DISTRICT OF COLUMBIA
WATER AND SEWER AUTHORITY

DC CLEAN RIVERS PROJECT
GREEN INFRASTRUCTURE PROGRAM

**ROCK CREEK GI PROJECT C (RC-C)
PROJECT DESCRIPTION**

June 10, 2024

Figure 2-8. Rock Creek Project C: Area 4D-1

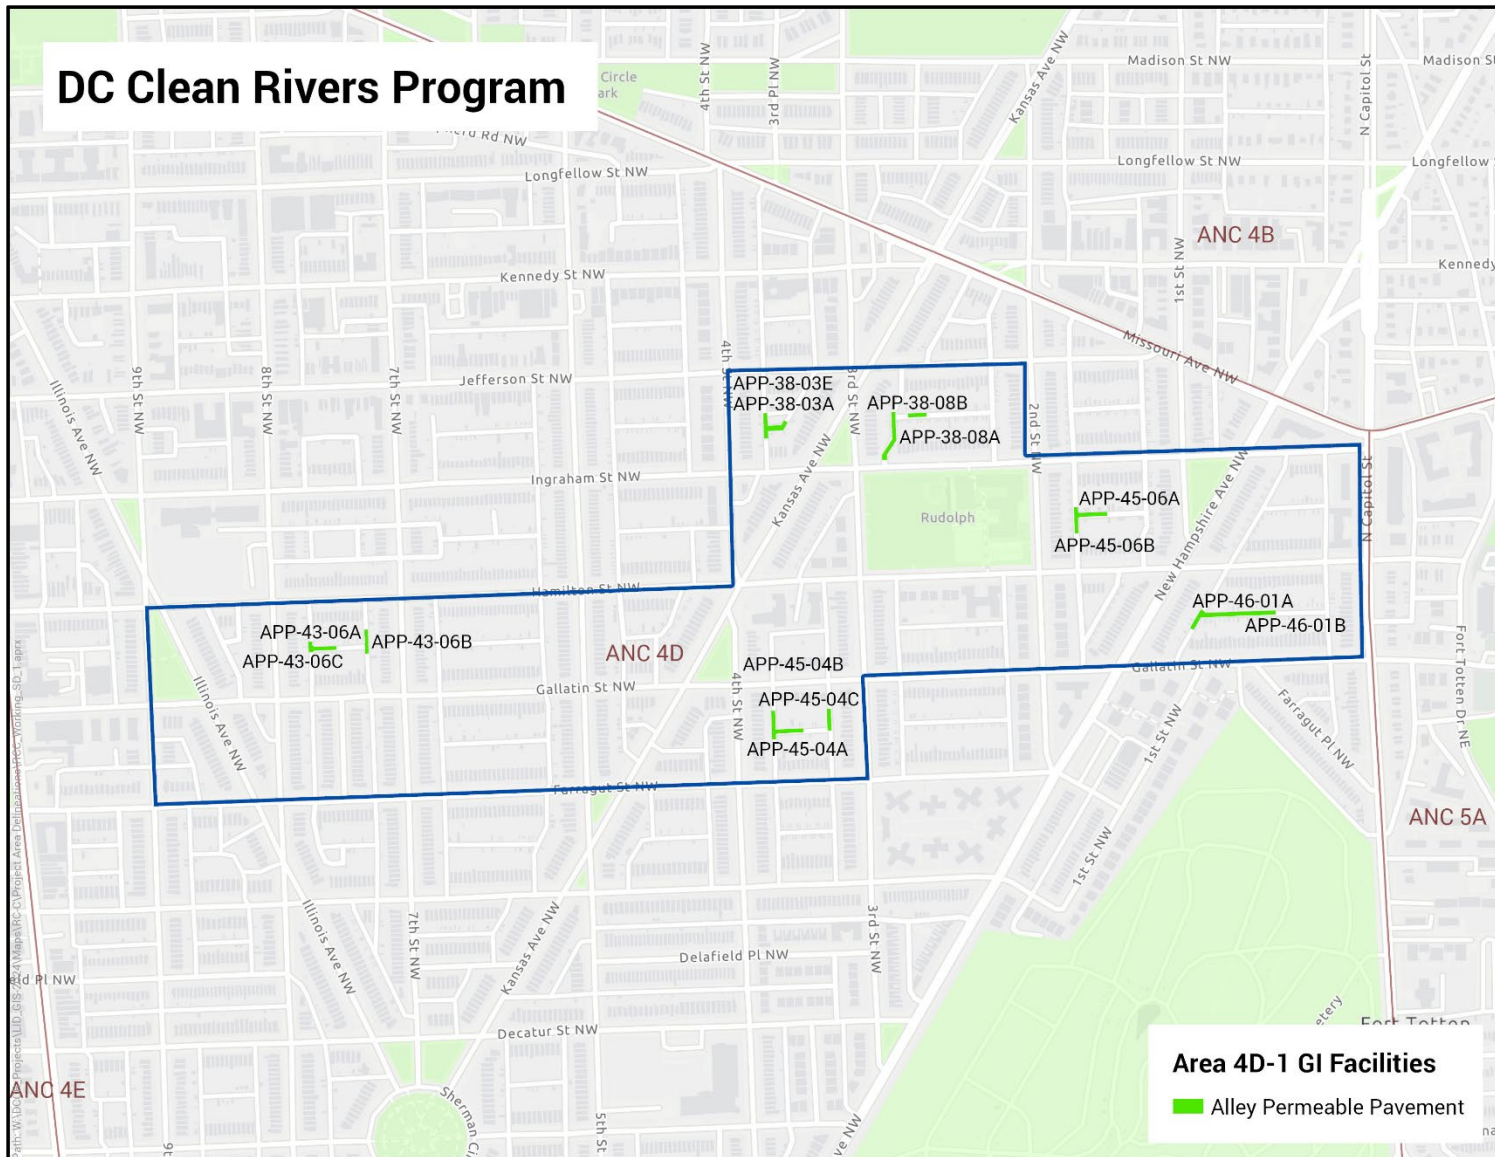
- a) Comment: Commenter pointed out that Rock Creek Project C, Area 4D-1, includes two permeable alley pavement facilities across two segments of the public alleyway; both lead directly to the rear of his home. Can DC Water construct each of these two permeable alley pavement sections at different times, so that the alley located between the two facilities always remains accessible?

Response: DC Water will coordinate with the contractor to establish a construction sequence to ensure that the two affected areas of the alley are not under construction at the same time.

Figure 2-9. Rock Creek Project C: Area 4E-1

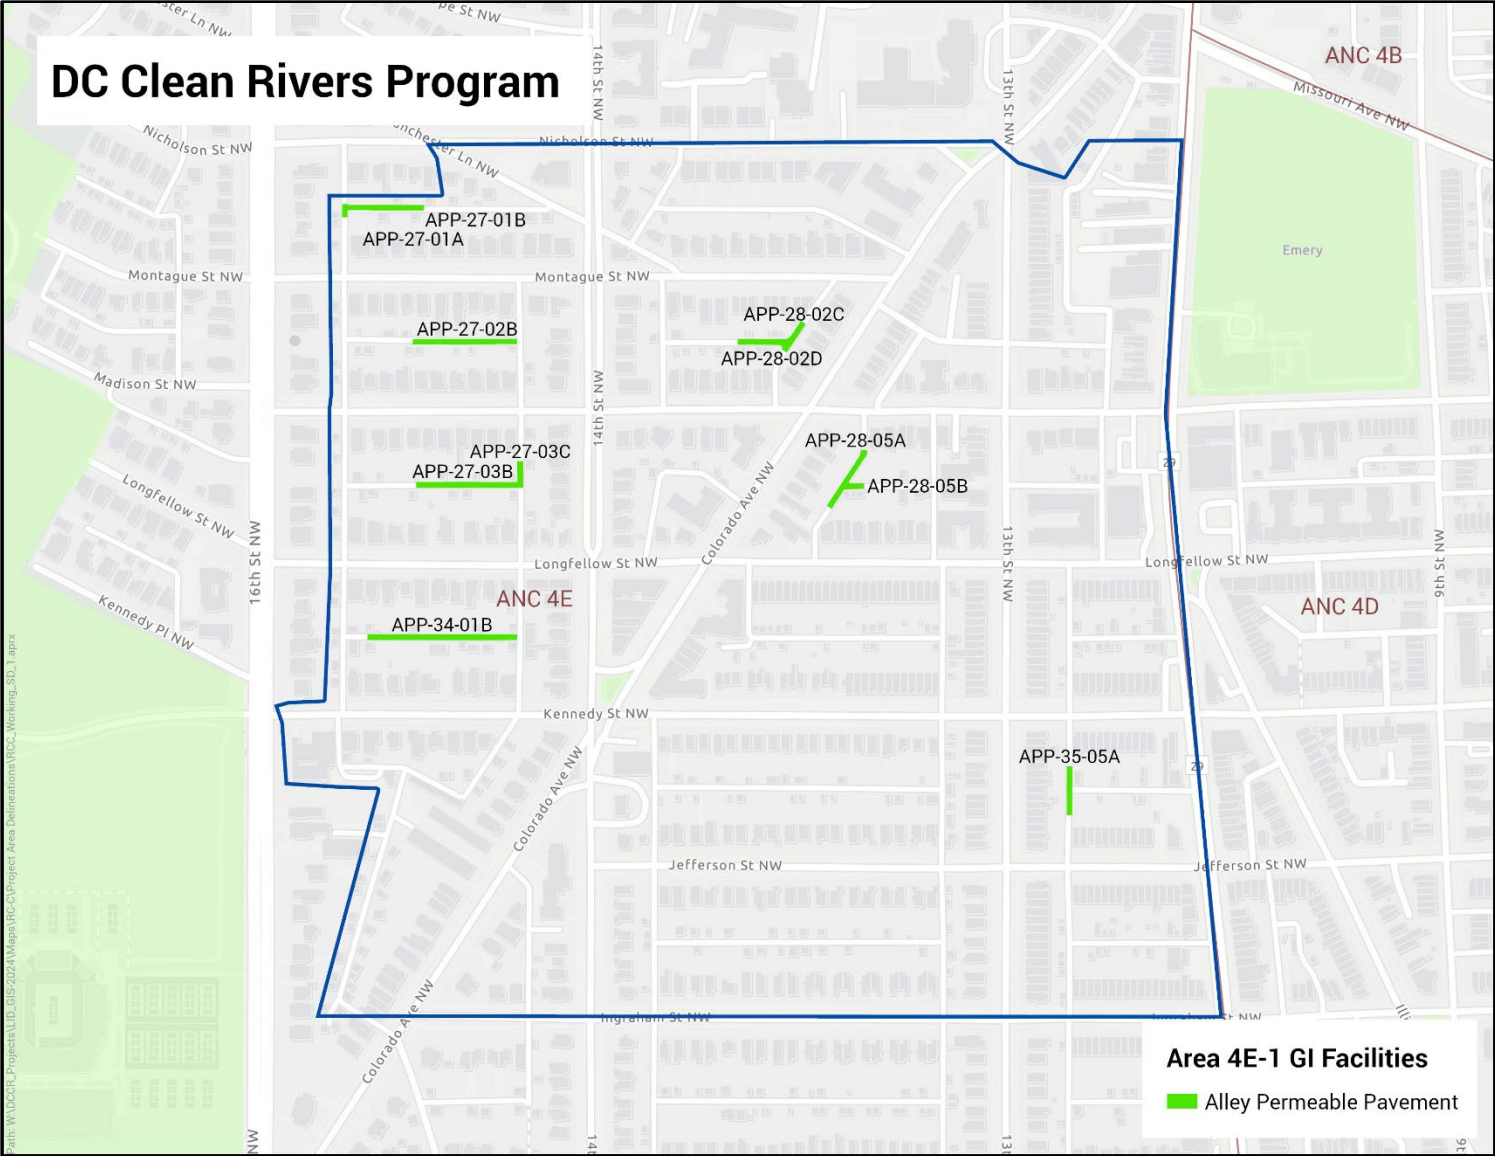
- a) Comment: Commentor has concerns about the Rock Creek Project C, Area 4E-1. The brick pavement in the back alley has slowly become a green alley, with rubble building up between the gaps and weeds growing into them. Commentor asks if DC Water will use a long-lasting and durable solution such as concrete for the alley?

Response: Comment noted. DC Water has a routine maintenance schedule for all permeable alleys to ensure long term viability of the facility. Residents are encouraged to contact DDOT for maintenance concerns relating to non-permeable portions of the alley. DC Water will restore the portions of the alley beyond the permeable pavement to concrete only where it is disturbed during construction.

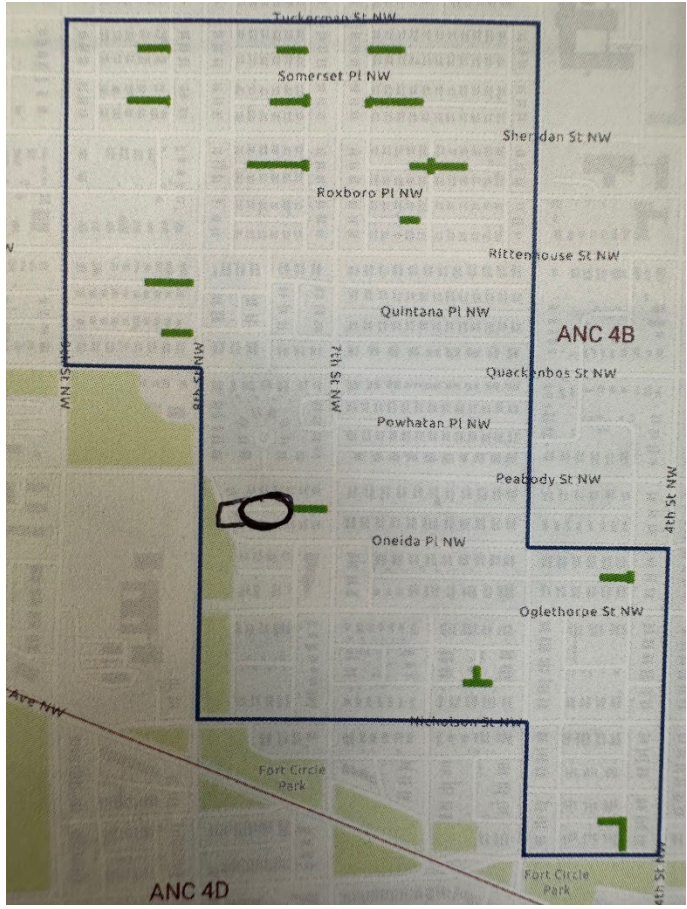
I would like to request that the permeable pavers be extended slightly in our alley (see the attached picture - I circled it). The reason for this request is because all of our houses are at the bottom of the big hill (in between Oneida and Peabody) and we receive HUGE amounts of drain off during storms. Our house is one of the only houses on the block with a sump pump, and it literally continuously pumps water all year long. Also, in August 2020 a huge storm completely flooded our basement, causing over \$20,000 in damage and needing it to be completely ripped out.

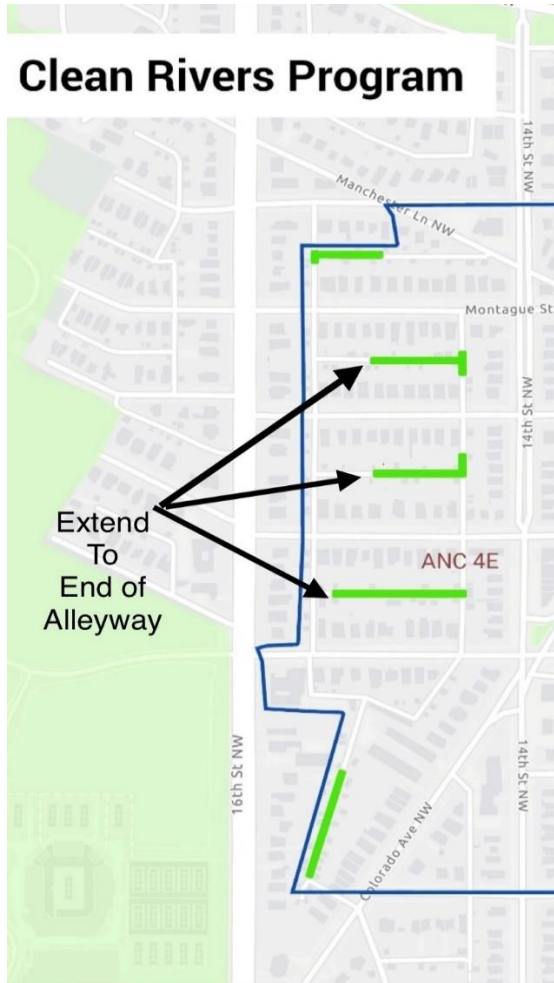
I fully support the proposed permeable alleyway, to be installed between the 1500 blocks of Webster & Allison Streets NW. I would encourage DC Water to expand that as fully as possible within the alley, and behind Mosaic Church [REDACTED]
